02 February 2023

WOOD MIDDLE SCHOOL MODERNIZATION & NEW CONSTRUCTION

Design Meeting #3 – MEETING NOTES

SPACE NEEDS SUMMARY

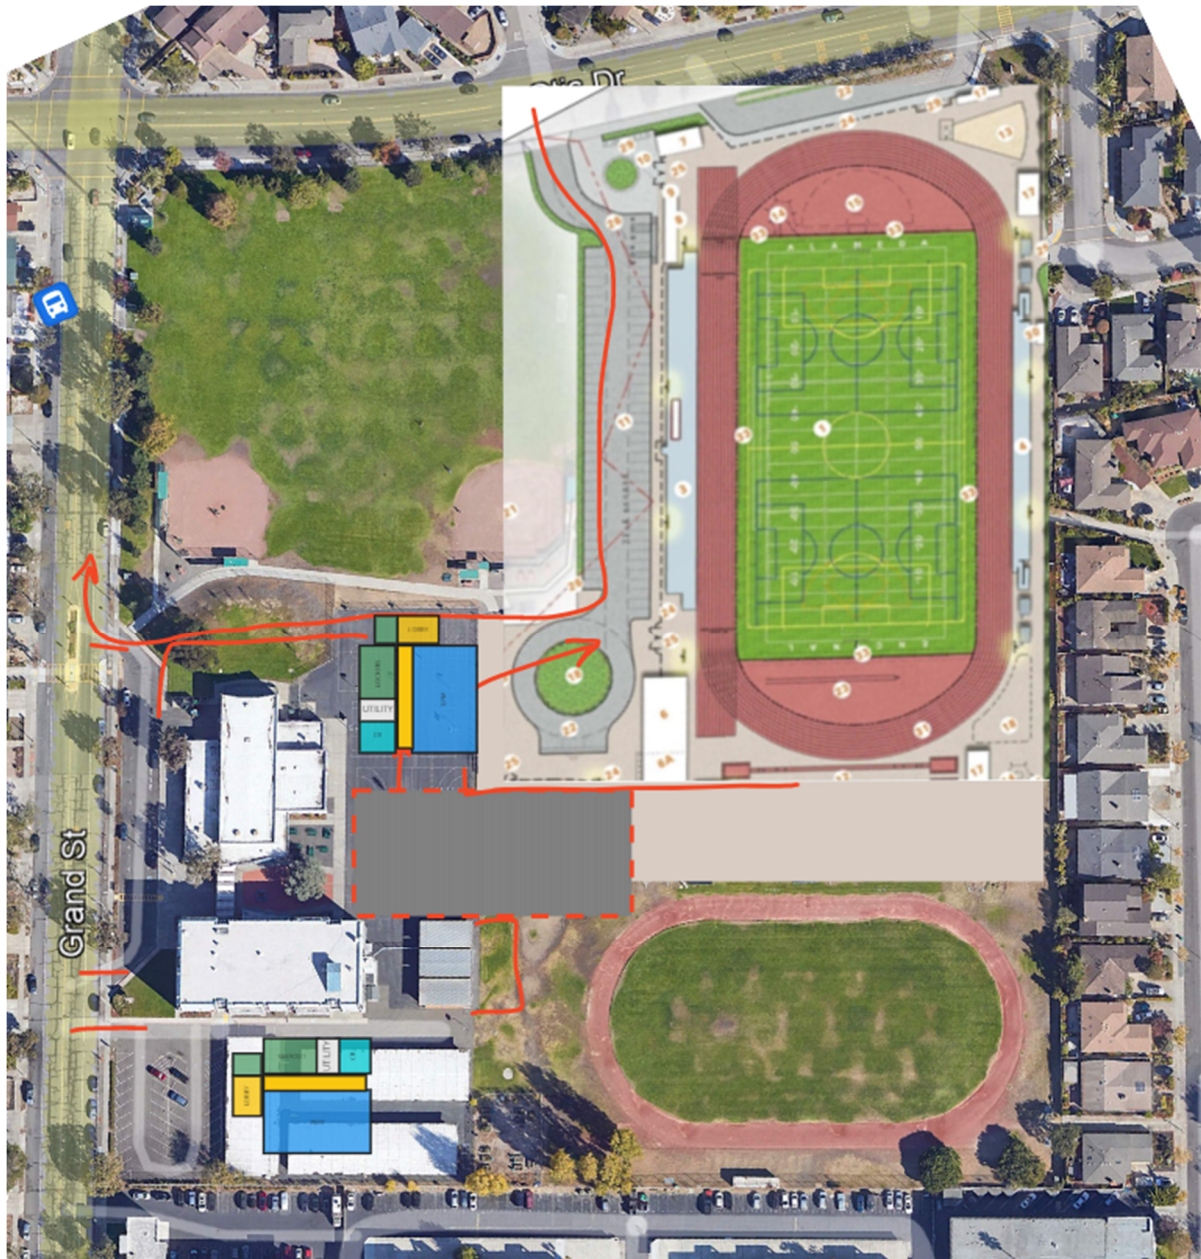
- Joel [JW] explained that the # Students column in the spreadsheet represents the “functional” or useful capacity of listed classrooms.
- What are the classrooms used for when they’re not occupied? Per Principal [KD], they are used for informal meetings, as break room, and pull-out space.
- Could Mild/Mod and Mild/Mod/Math share classrooms so the spaces would be occupied/used full time? The classroom utilization rate in the spreadsheet currently shows them low.
 - This could possibly happen per Principal [KD]. The current classrooms are “Tom’s room, Armstrong’s room, and Martinez’s room”. There would need to be a “landing space” or office for the teachers if this happens.
 - If Mild/Mod and Mild/Mod/Math can share classrooms and are used 100% in every period, then it could open up areas for other desired spaces.

- Principal [KD] commented in Zoom chat that “the intensive students share a classroom space every day, so they occupy 3 rooms”.
- Holly [HS] commented that intensive needs number is going up and that another space may possibly be needed in the future.

- Principal [KD] mentioned that SDC Office is not in the spreadsheet. Joel [JW] responded that SDC Office is not counted as a learning space and therefore it is not in the spreadsheet. Principal [KD] understood and is ok with it not being on the spreadsheet.

- Joel [JW] mentioned that QKA had a separate meeting with Kai on Admin spaces and asked if there were any spaces or needs missing in the spreadsheet.
 - Lindsey [LS] asked if there will be restroom in the Admin space for staff? Restroom will be provided in Admin. It is listed in the Miscellaneous section of the spreadsheet.

- Principal [KD] commented that coach Kyle’s office needs to be in the Admin space. He is the Student Support Provider and works closely with admin staff. He is a life coach for kids and not a technical coach.
